**PLANNING COMMISSION
STAFF REPORT**

AGENDA ITEM: Planning File No. MODSP-26-0001: A modification to MAJ-24-0005 and CU-24-0001 to make modifications to the proposed building materials, number of decks, number of windows, along with other minor modifications described in the applicant’s narrative.

LOCATION: 200 N 7th Ave / Lot E-2 River Pines Sub Resub Outlot E Replat A River Pines

1. Horizontal Wood Siding

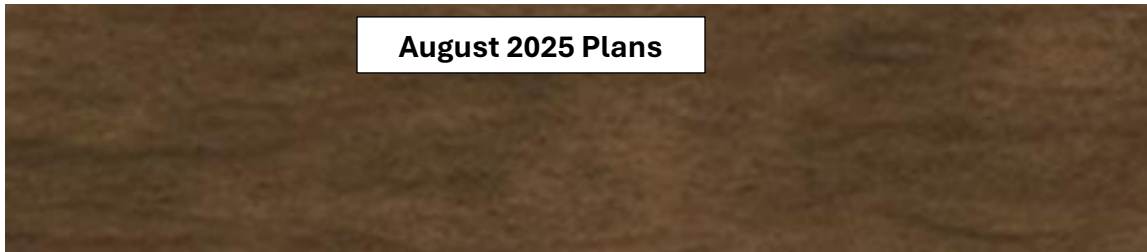
Per the Application, the wood siding specified in the original approval has proven difficult to obtain. The Applicant therefore proposes replacing the originally approved wood siding with LP SmartSide lap siding, an engineered wood product designed to replicate the appearance of cedar. The proposed siding will be eight (8) inches in width and will match the color of the previously approved material. Staff finds that the proposed material is similar in appearance to the originally approved siding and maintains the overall design intent.

SAFFRON CEDAR

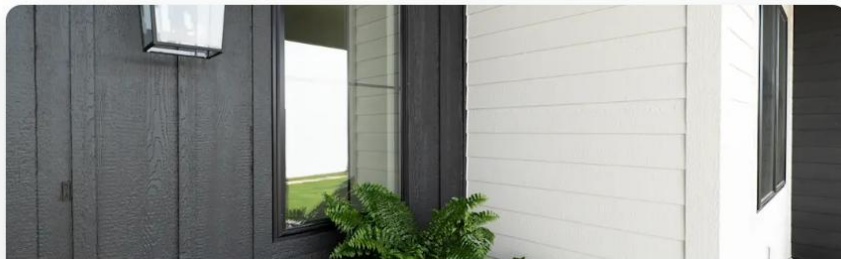
The original application specified fascia siding as a standard cedar product. To maintain consistency with the proposed LP SmartSide horizontal siding, the Applicant proposes using LP SmartSide fascia siding, an engineered wood product designed to replicate the appearance of cedar. The proposed fascia will be the same width and match the color of the originally approved material. The image provided from the August 2025 application of the fascia wood siding in the picture below represents the appearance and finish of the fascia siding as well. Staff notes that this product is commonly used throughout the Town and finds that the proposed change maintains the overall design intent and visual consistency of the façade.

Staff obtained this Information from the website regarding LP SmartSide fascia, which the Applicant verified as accurate.
